AGENDA
CITY OF GLENWOOD SPRINGS
SPECIAL CITY COUNCIL MEETING
JULY 29, 2021
101 W. 8TH STREET
6:00 PM

City Council
STAFF REPORT
City of Glenwood Springs
July 29, 2021

Agenda Item: 09-20 Consideration of an Annexation and the initial zoning/Rezoning of 15.818 acres to Commercial (CO) District and Planned Unit Development (PUD) District at 214 Center Drive (PIN: 2185-061-00-042).

TITLE	OFFSITE DRAINAGE PLAN
DRAWING NO.	C-4.0

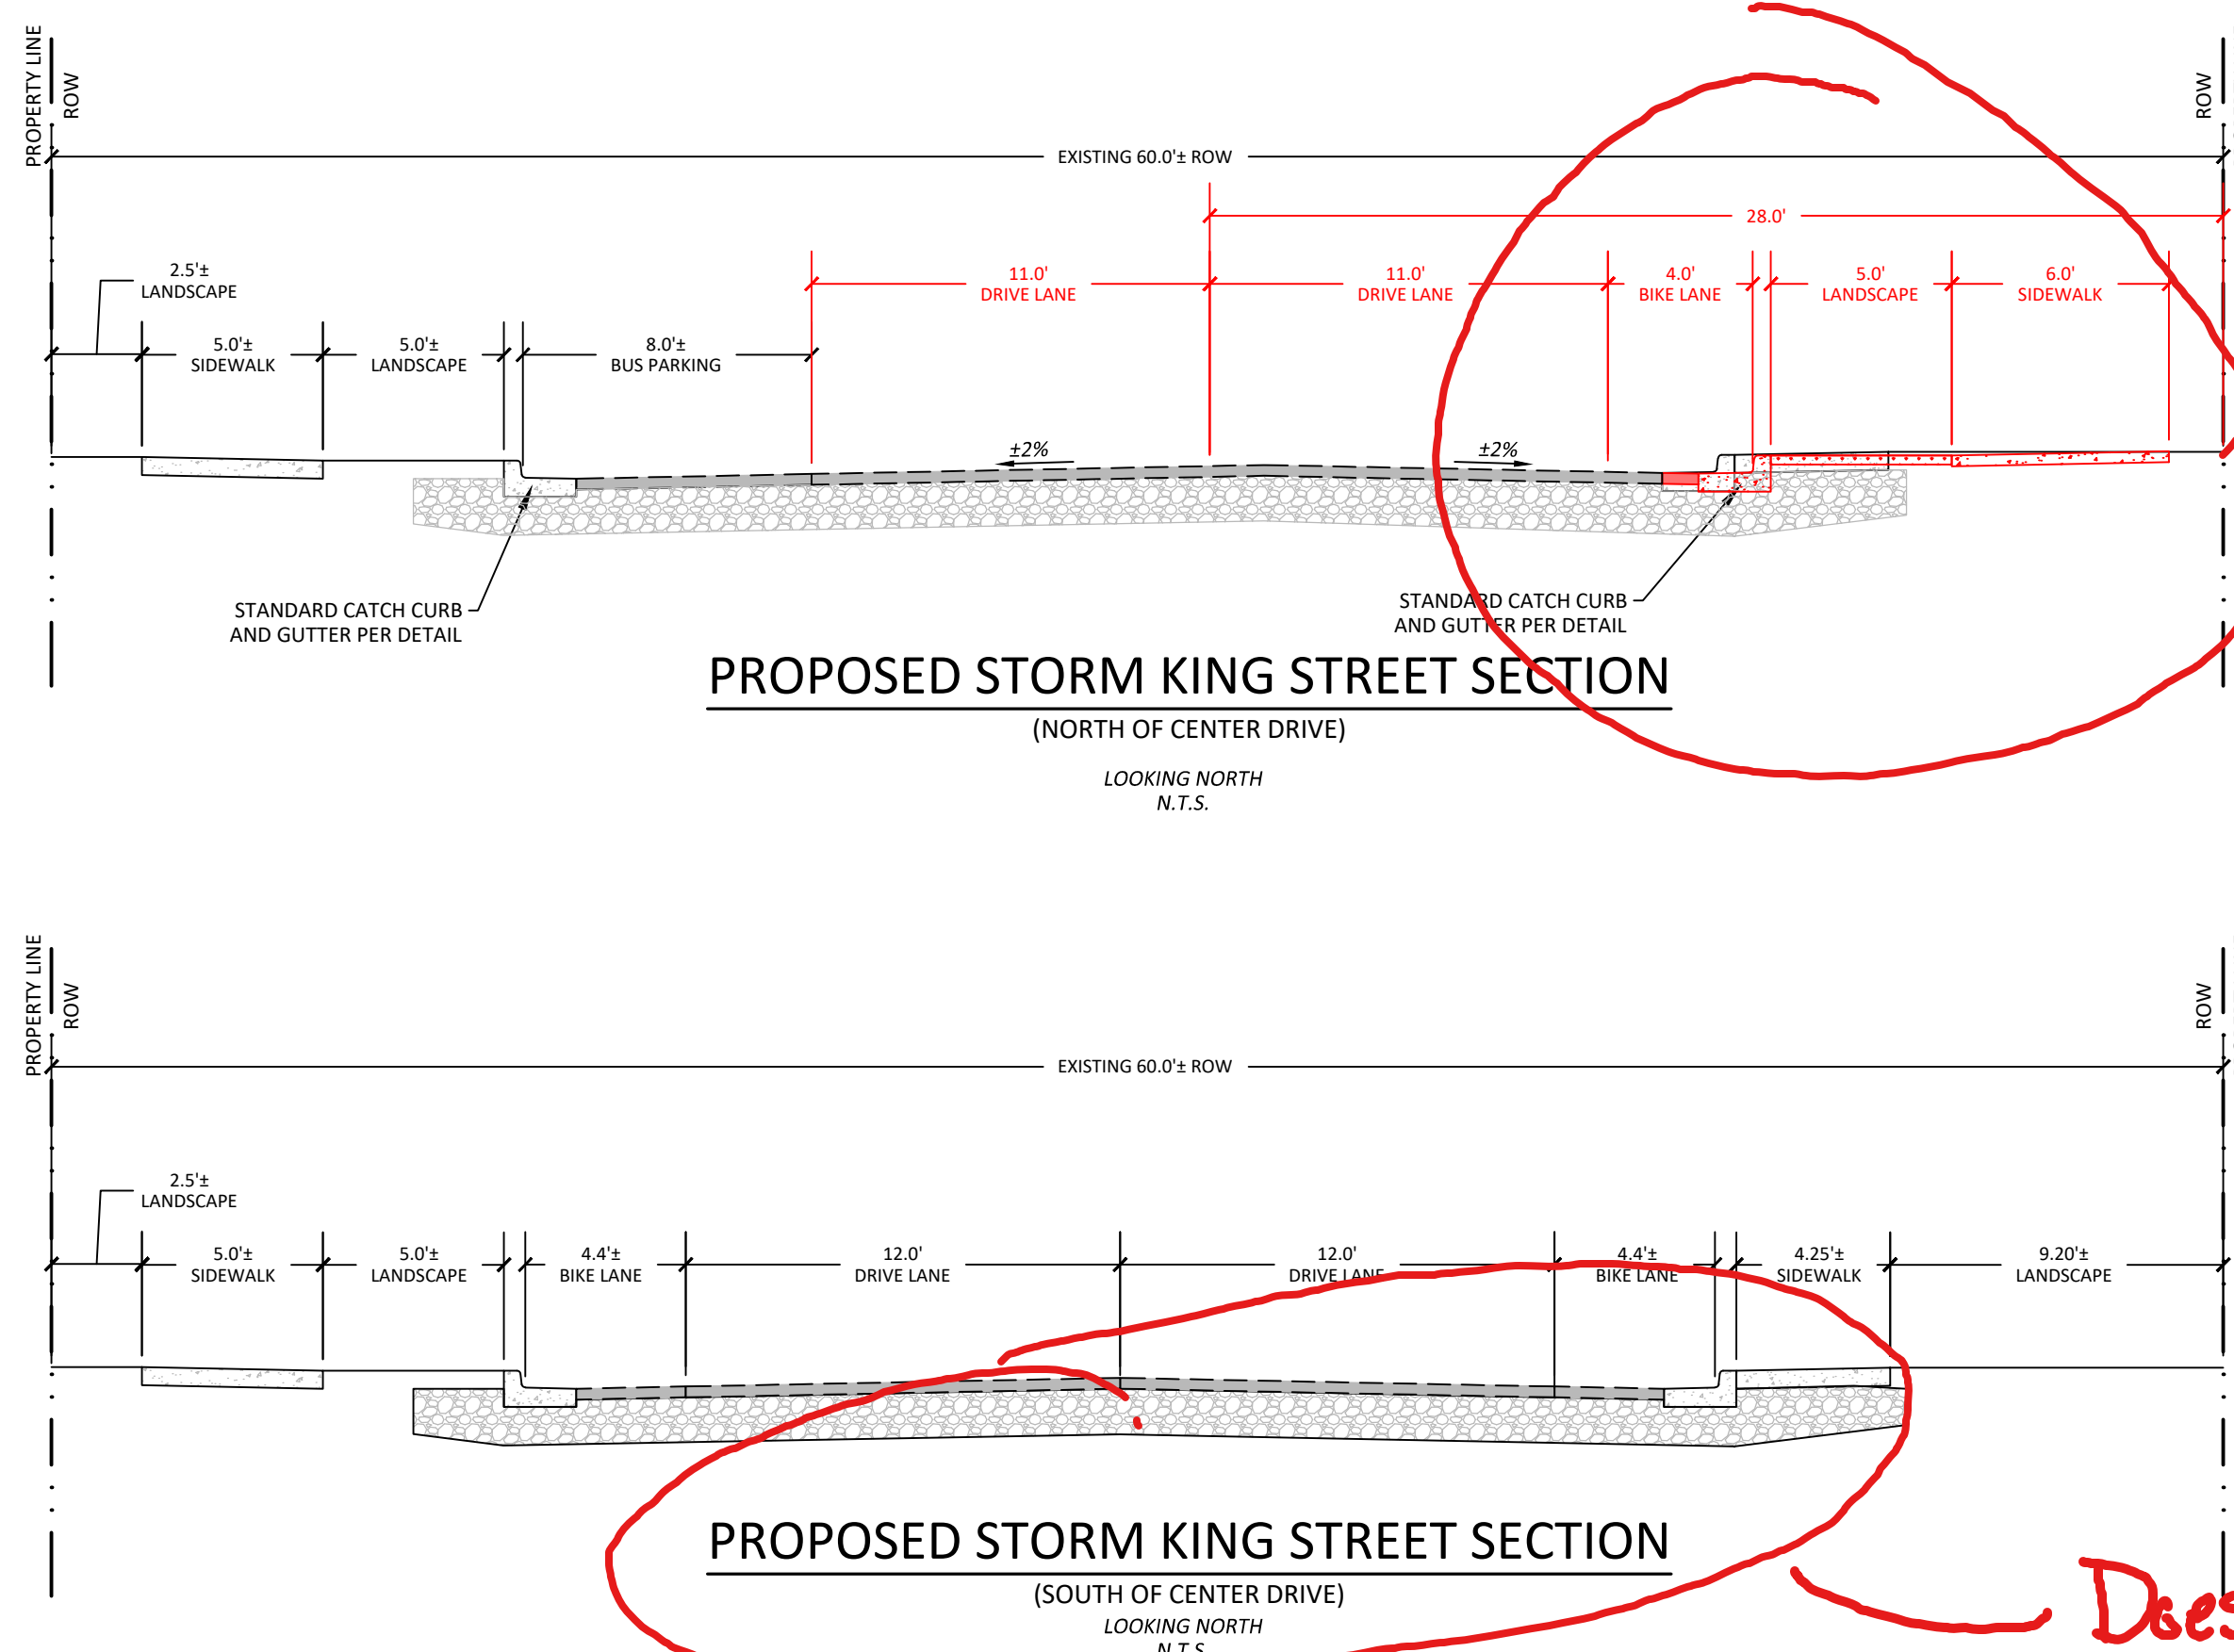
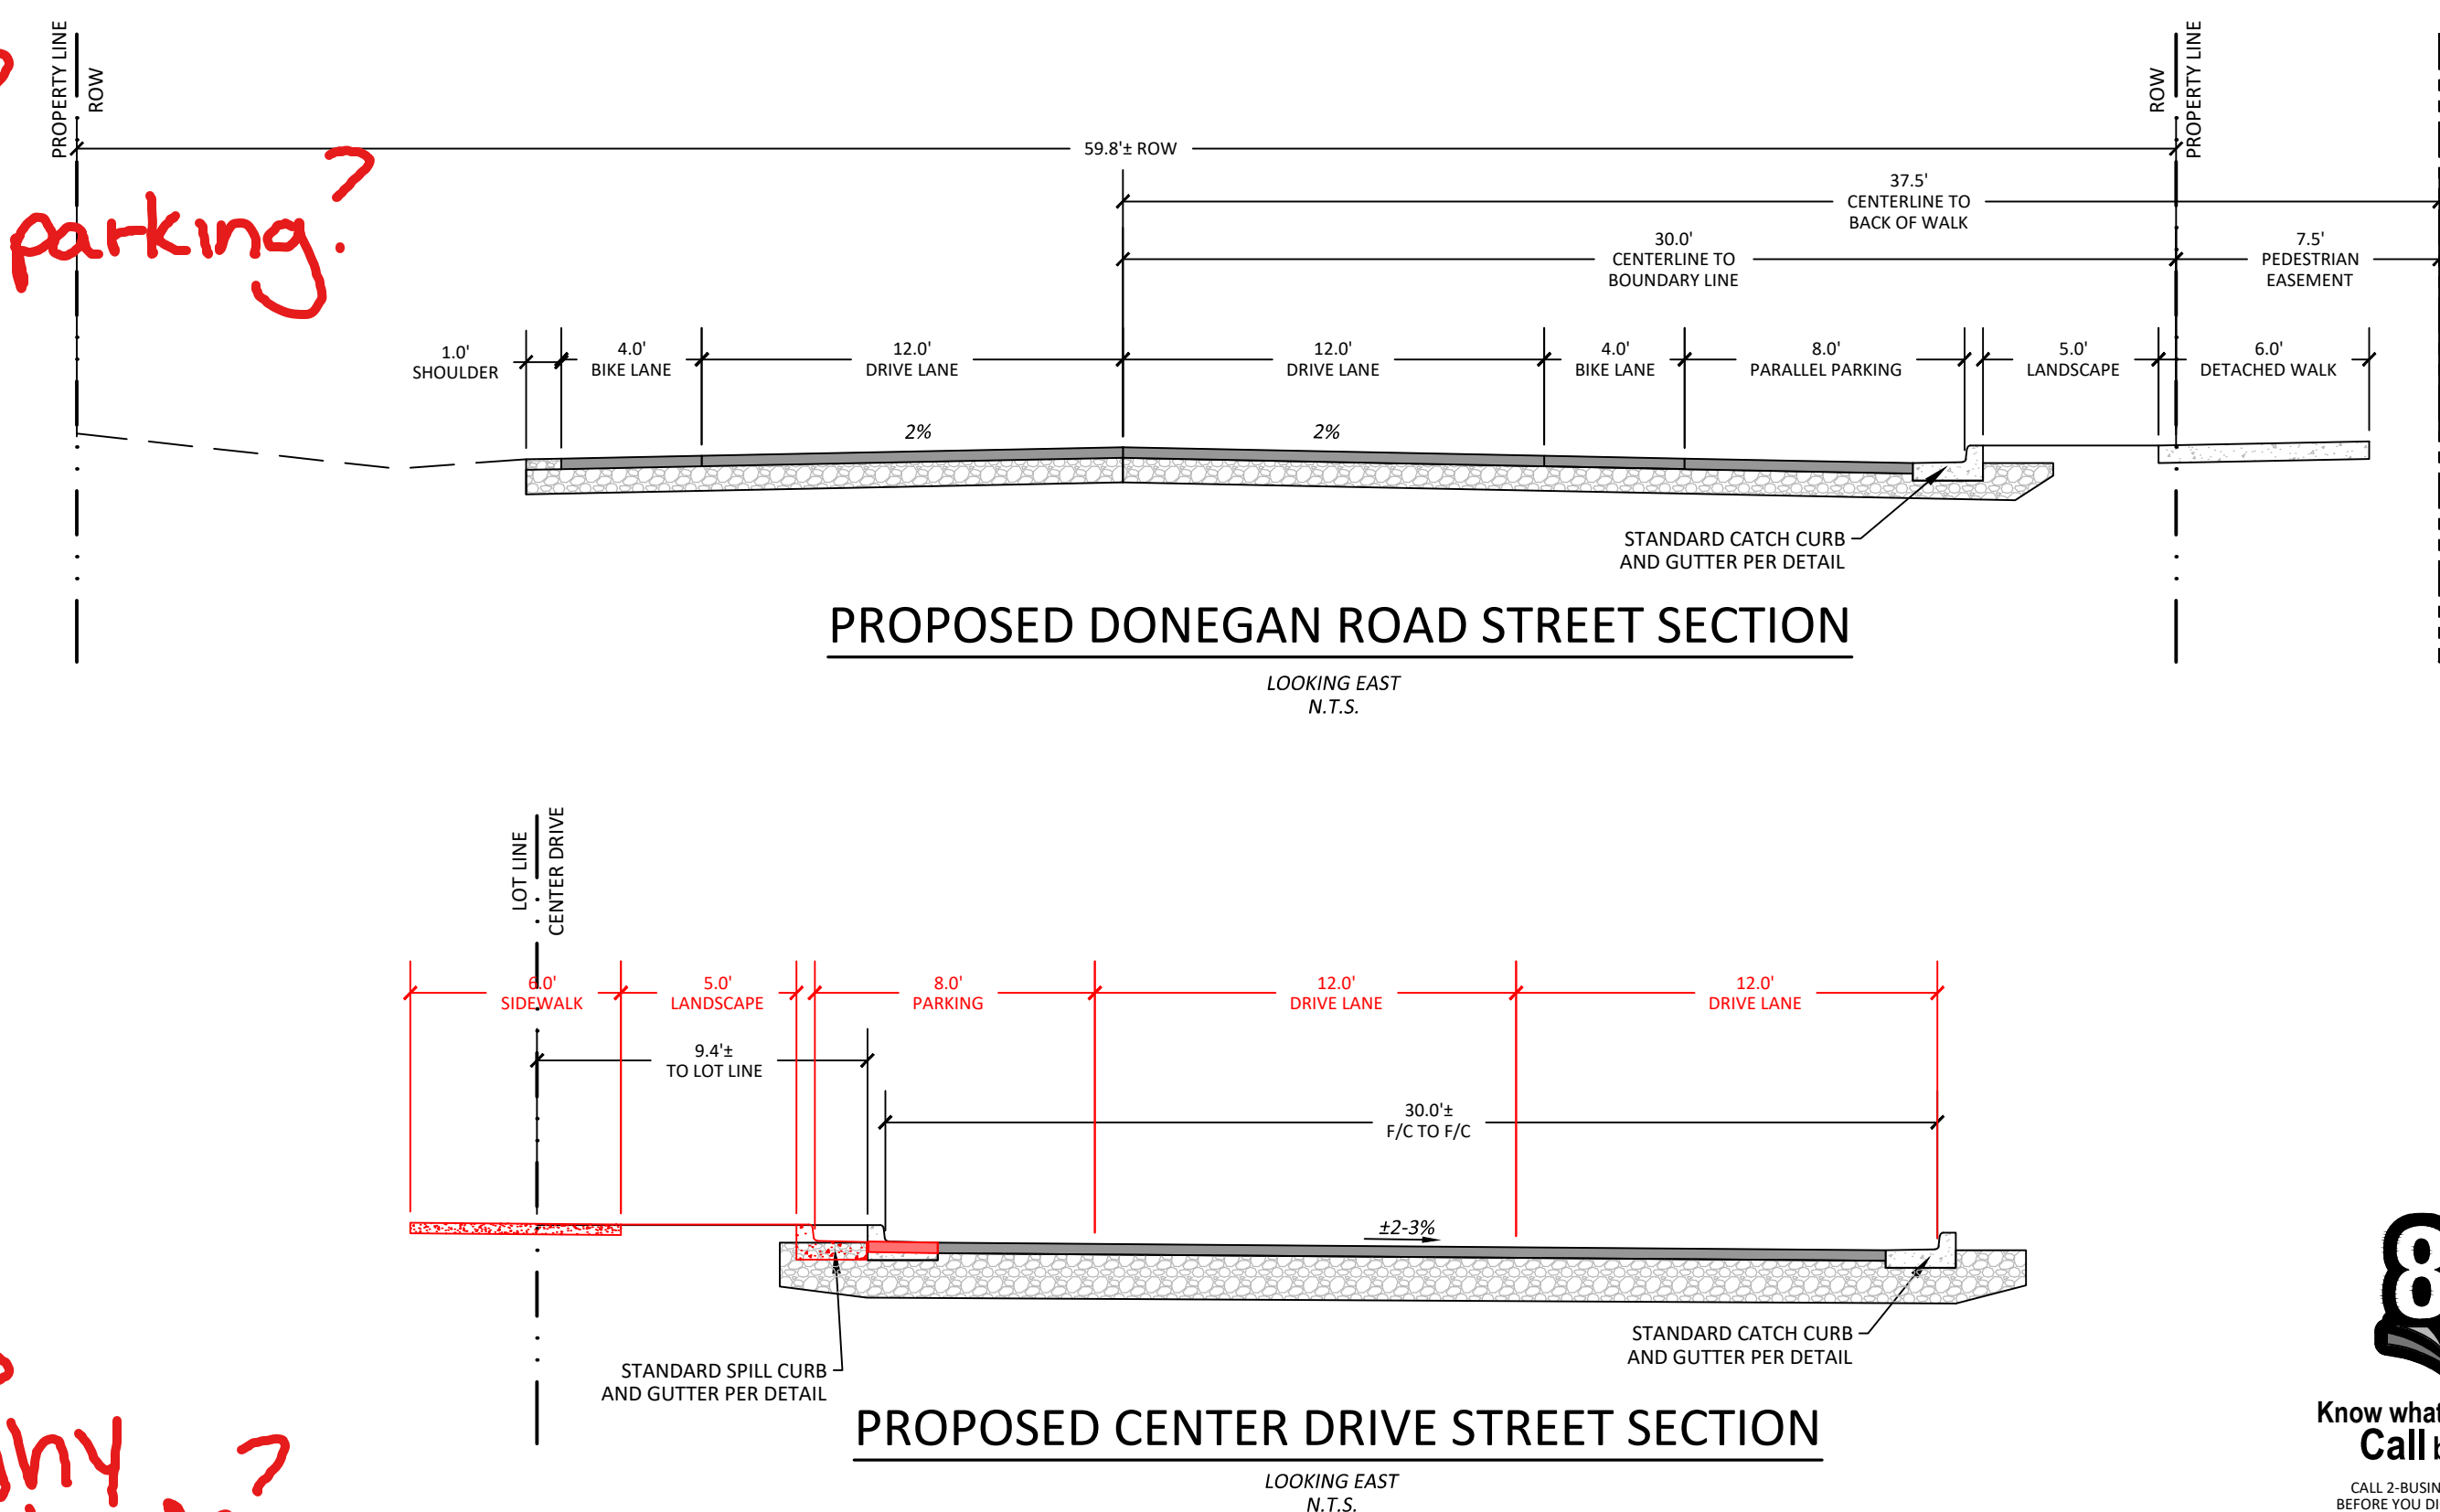
- Doesn't appear to be changing - why shown?
